Meeting Agenda Building Board of Appeals

[22-1564](#) BBA22-2002 - Staff Report for 616 E. Washington, Ann Arbor, MI 48104

Staff Report: Proposed screening room temporary exit arrangements

- TEMPORARY EGRESS FROM THE MICHIGAN THEATER SCREENING ROOM ON 616 E WASHINGTON STREET DURING A PORTION OF THE CONSTRUCTION OF THE HIGH RISE.

PROPOSED EXITING DURING TEMP MEANS OF EGRESS (APPROX. 180 DAYS)

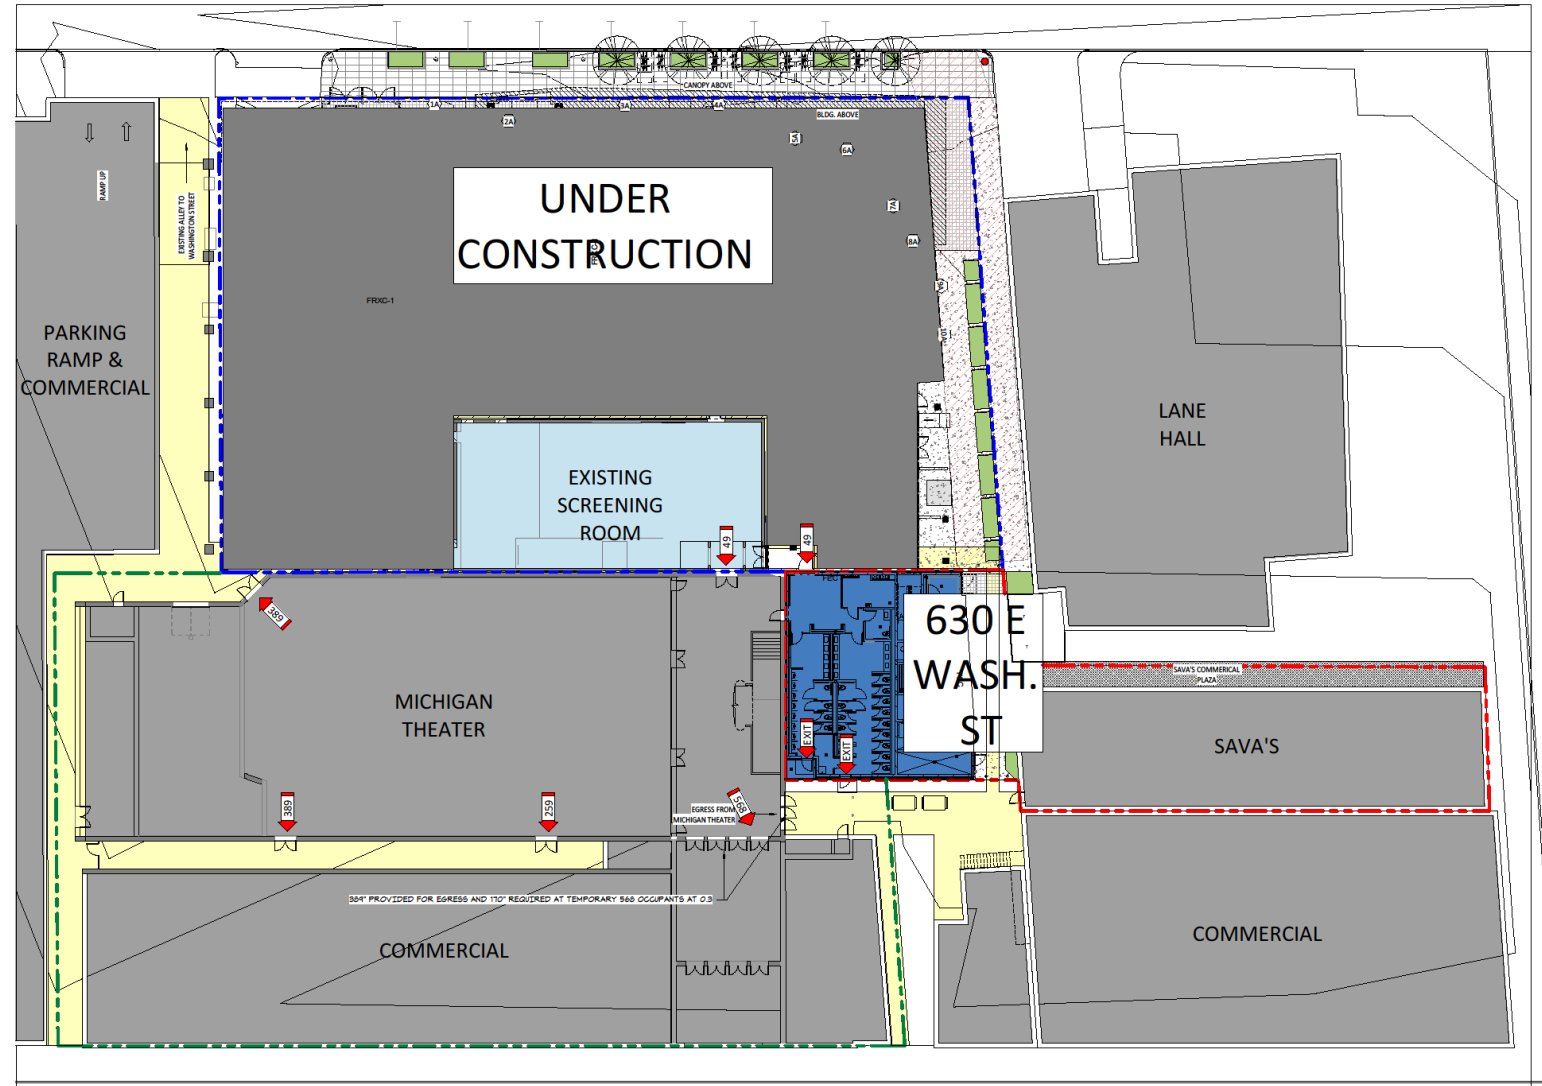
Petitioner requests approval to provide a single exit from the screening room during Stage 3 of the construction sequence, limiting the occupant load of the room to 49 based upon allowances of Table 1006.2.1 of the Michigan Building Code. In lieu of egress discharge directly to the exterior, the petitioner is asking to use the lobby of the Michigan Theater as well as the toilet rooms of another adjacent building under construction as discharge elements.

The maximum occupant load limit for a single exit assembly occupancy space, is 49 occupants. While the petitioner indicates that the screening room will be limited to 49 occupants the drawing shows over 180 seats and the appeal further indicates a full occupant load of 257 persons, presumably to take into account the lobby standing area immediately adjacent in the building.

The number of fixed seats shown is approximately 180. For areas having fixed seats and aisles, the occupant load is required to be determined by the number of seats installed and at a rate of not more than one person for each 18 inches of seating length (MBC 1004.4). The occupant load for areas in which fixed seating is not installed, such as waiting spaces, is determined in accordance with section 1004.1.2 and added to the number of fixed seats.

The proposed exit passageway in this case does not exit directly to the exterior of the building and in fact enters two other buildings where the path continues. Configured as they are, they are not any form of acceptable exit discharge as there is no exterior to discharge to.

The exit passageway opens into rooms of two adjacent buildings, each on a separate lot from that of the Screening Room. The code text assumes, however, direct access to the exterior which must then lead directly to the public way. Upon leaving an exit, entering other enclosed space (whether the same building or another) is not permitted. In this case, occupants are no longer in the protected path of the enclosed exit passageway nor are they in exit discharge on the exterior with direct access to the public way.

Egress into the toilet rooms is also not considered to be exit discharge. Also note that prior to reaching the actual toilet rooms there is a common toilet room lobby which shares a door to the Michigan Theater lobby. The route will likely cause additional confusion emptying first into a common lobby, and then either of two toilet rooms. The difference between the door into the Michigan Theater building and the door into the toilet room lobby building is estimated to be about 15 ft. and as such there is effectively no difference between entering the Theater and toilet room lobbies. In addition, at the end of both paths occupants are at the same point at the exterior and have still not reached a public way.

Staff does not support any portion of this request. Staff believes the code has been correctly interpreted, does apply, and that the proposal is not an equal or better form of construction. There are too many potential hazards inherent in this request to allow staff to be in support, given the lack of compliance to technical provisions of the code and the dangers of conditions on construction sites.

PROPOSED EXITING DURING THE DURATION OF CONSTRUCTION

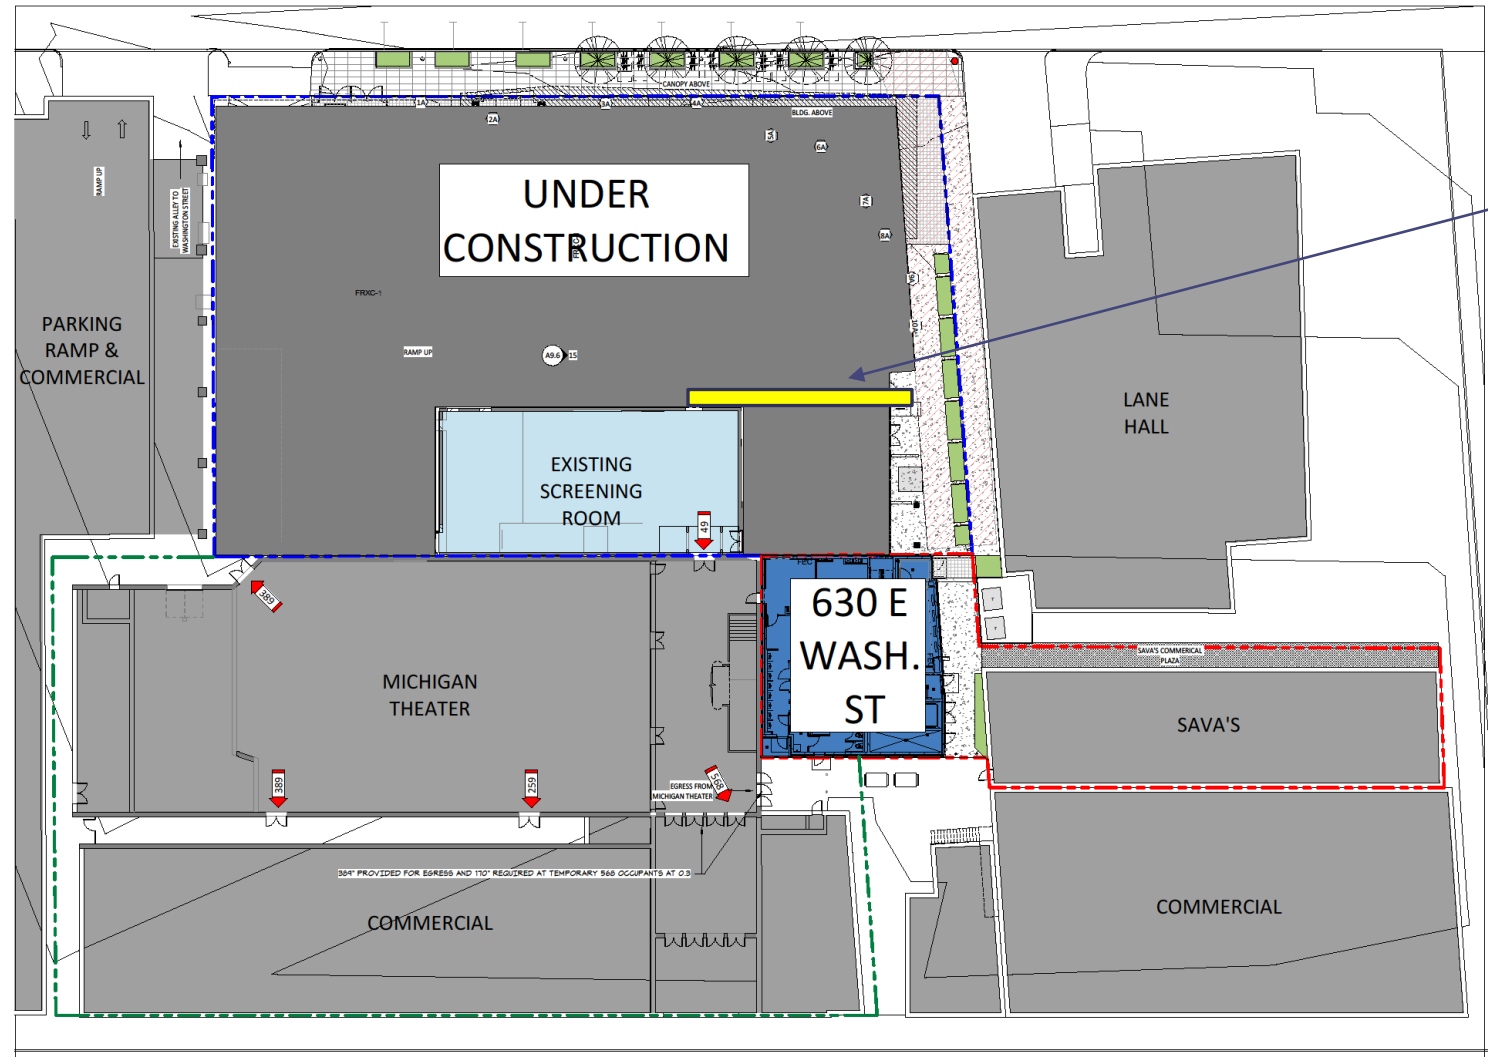
Petitioner also proposes a non-compliant means of egress plan for Stage 4 of the construction process. Petitioner seeks approval to allow the Screening Room Building to operate at full capacity for over a year and on an active construction site. The proposal is to create a second egress path in-part within the high-rise construction building and in-part onto the construction site. The total load is stated as 257 people for the screening room. The egress is described as “various egress routes” with little detail.

Construction sites are statistically some of the most dangerous work environments, even for highly trained and skilled workers. Precise control of these sites is difficult and requires constant supervision, even during the dormant hours when no active work may be occurring. There is always a possibility for multiple operations ongoing at any one time, and sites are left each day in an uncompleted state. Hazards may be present in the form of stacks of materials, ladders, lifts and tools, open areas between floors, live electrical components, uncompleted fire protection systems, hazardous material storage and construction waste. No matter how well intentioned, there are lots of situations which may present obstacles or dangers to egress. It is generally not a safe work practice to allow untrained non-construction personnel around the site, whether during or after working hours, especially in an undefined egress path. Sites are also typically locked at night, so that access to the public way could be impeded or impossible.

The pedestrian protection required by the Michigan Building Code in section 3306 is intended for pedestrians adjacent to, but not on a site, as understood by the distance criteria being measured to the lot line - with no internal site distances referenced.. The reason so many streets and sidewalks are closed during a large construction process is directly related to pedestrian safety. Again, it is not assumed the general public will be allowed access to a construction site.

Finally, while there are no differences proposed on the Michigan Theater / Toilet Room side from that of Stage 3, some changes would be needed. During a two exit scenario doors on the eastern wall of the exit passageway and from the toilet room lobby into the exit passageway would need to be reversed. All doors involved in egress during Stage 4 would also need to be equipped with panic hardware (MBC 1010.1.10).
